SB-GA8-2015-125

Issue 1

Service Bulletin

This Service Bulletin authorises the installation of a filter capacitor across the input terminals of the 14V system controller.

Figure 1 – View looking directly at the Caution Tray Assembly. Aircraft wiring not shown.

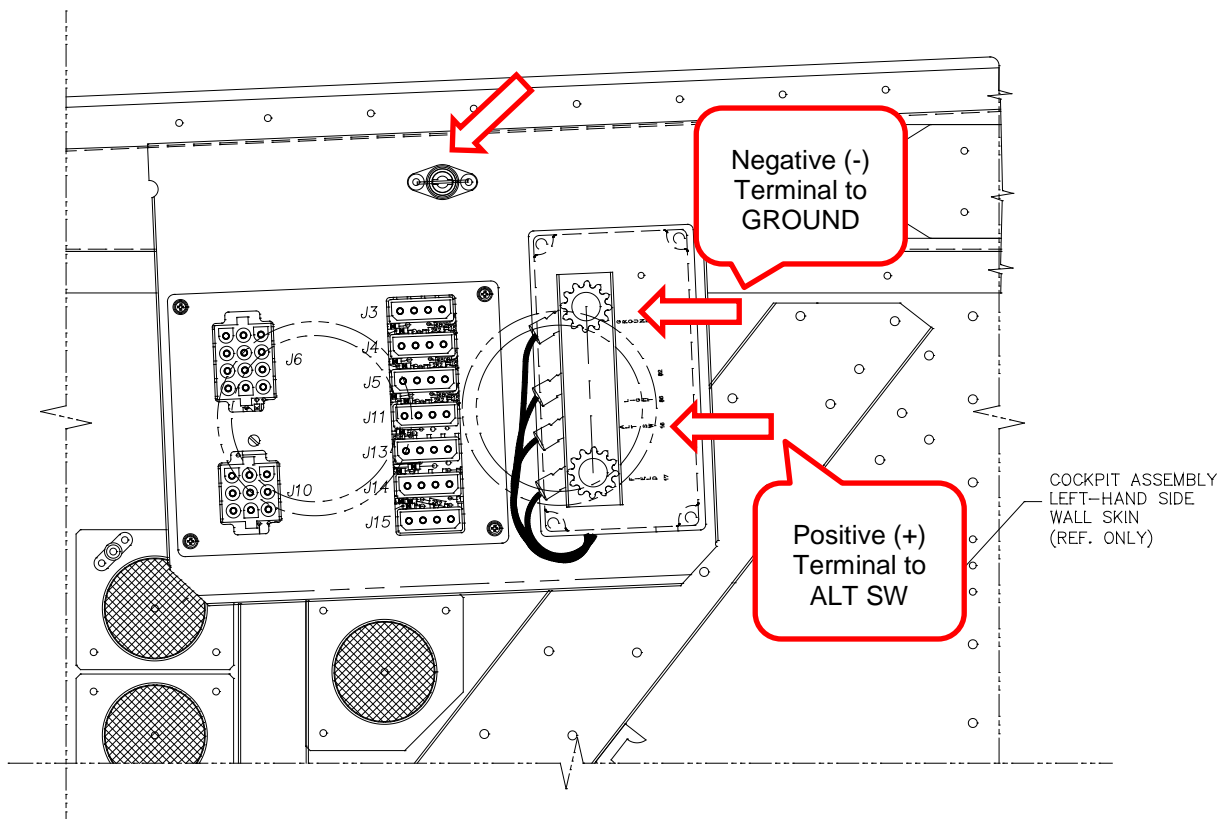
1. The aircraft shall be powered down.
2. Remove the starter key and pull all Solenoid Box circuit breakers.
3. Access the system controller panel by lowering the kick panel below the instrument panel forward of the pilot seat. It is possible to install the filter capacitor without removing the Caution Tray Assembly. This will depend upon the specific aircraft configuration such as whether an Electronic Flight Instrumentation System is fitted or not affecting accessibility to the System Controller. If the panel is to be removed, rotate the dzus quarter turn screw located at the top of the tray. Refer to Figure 1.

4. Identify the ground and the Alt Switch terminal of the 14V system controller. Refer to Figures 1, 2 and 3. Figures 1 through 3 shows System Controller p/n GA8-243014-011. This Service Bulletin also applies for instances where System Controller p/n GA200-243001-001 is fitted with a similar installation.

5. Remove the insulating cover from the System Controller.
6. Remove the nuts and adjacent washers.
7. Carefully noting the polarity of the capacitor install the device to the Alt Switch (positive) and Ground (negative) terminals. Secure the Filter Capacitor to the aircraft wiring with cable ties. Carefully cut off the cable ties to ensure no sharp edges are present.
